Replies to reviews

“Towards robust seasonal streamflow forecasts in mountainous catchments: impact of calibration metric selection in hydrological modeling”

Diego Araya, Pablo A. Mendoza, Eduardo Muñoz-Castro and James McPhee

Figure 3. Flowchart describing the approach used in this study. See text for details.

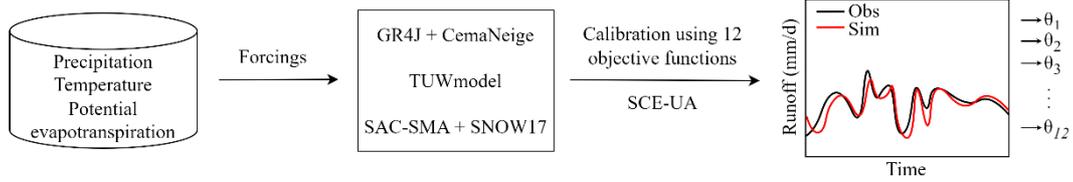
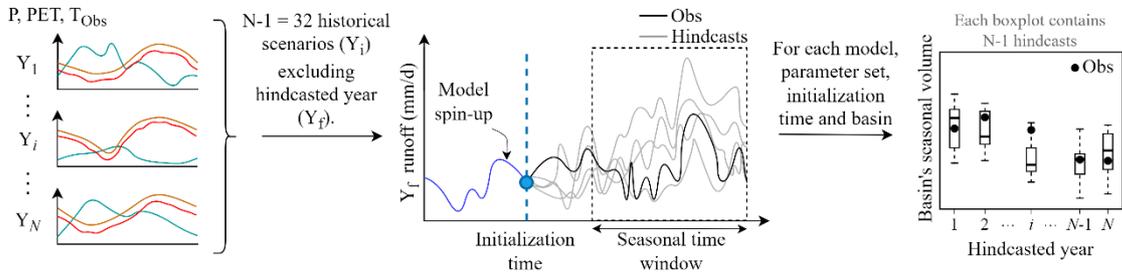
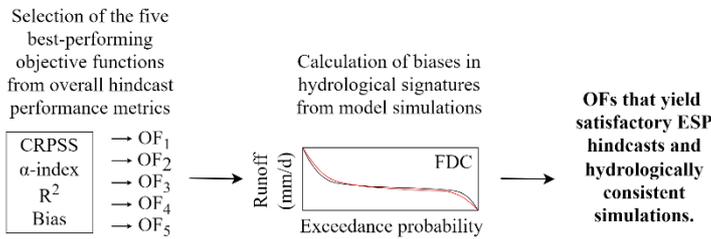
Sect 3.2: it could be useful to add a more detailed presentation of the ESP method (for instance by adding a reference to Fig. 3 of Crochemore et al., 2020; <https://doi.org/10.1029/2019WR025700>) and extend Fig. 3 that really helps to understand your framework.

We have designed a new and more detailed flow chart to explain the methodology. Additionally, we have added a diagram inspired by Figure 3 in Crochemore et al. (2020) to explain the Ensemble Streamflow Prediction (ESP) method.
